SECTION 16 PLANNING APPLICATION NO. A/YL-NSW/357

Further Information Submission

Response to Departmental Comments Table

Drainage Impact Assessment Report

Figure 3.3

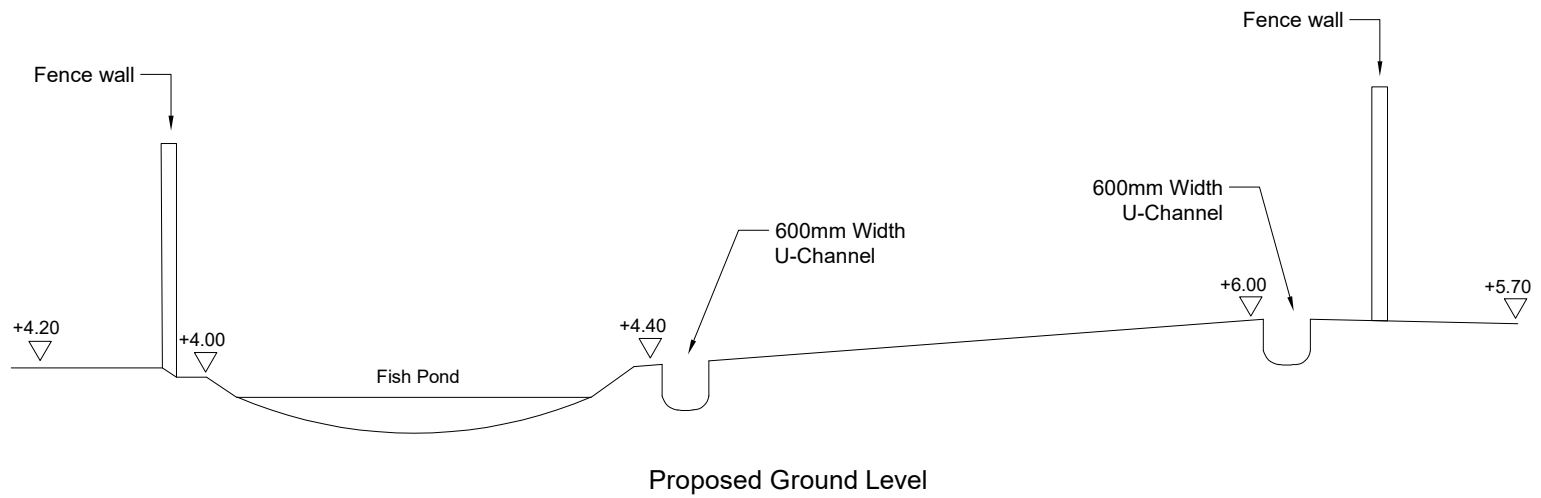
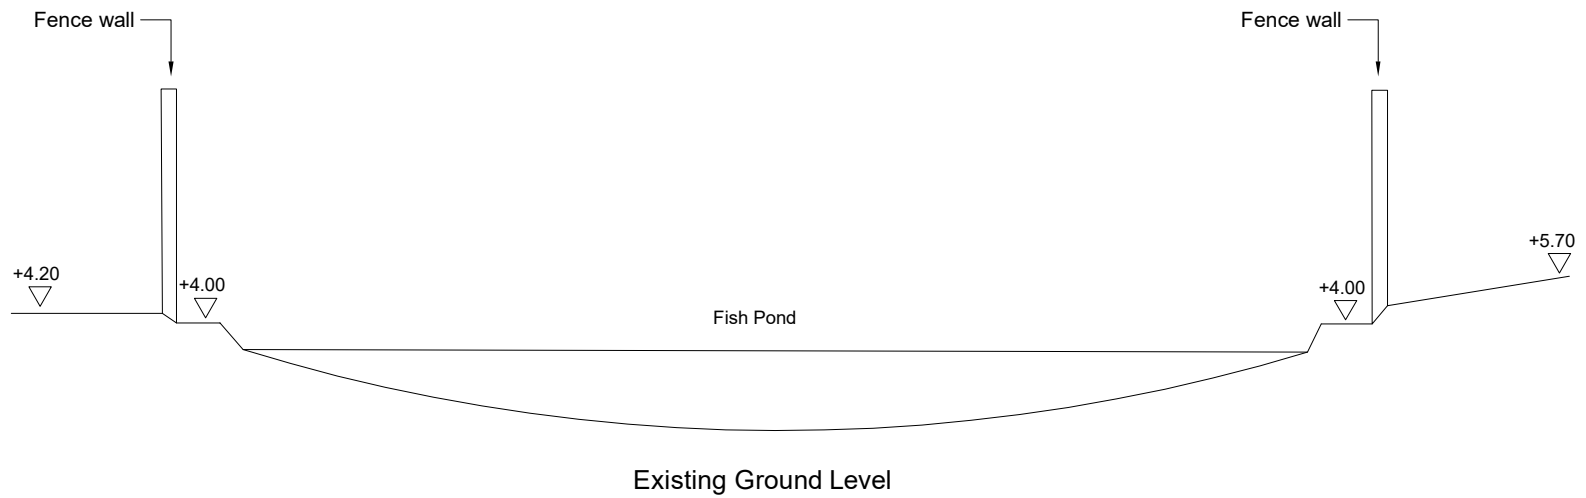
3.	Para. 3.2 & Figures 3.2 & 3.3: A sand trap/desilting type catchpit should be provided prior to connection to the proposed stormwater terminal manhole or to the downstream public stormwater drainage system;	Catchpit with sand traps is provided prior to connection to the proposed stormwater terminal manhole. Please refer to Figure 3.2 and Figure 3.3 of DIA .
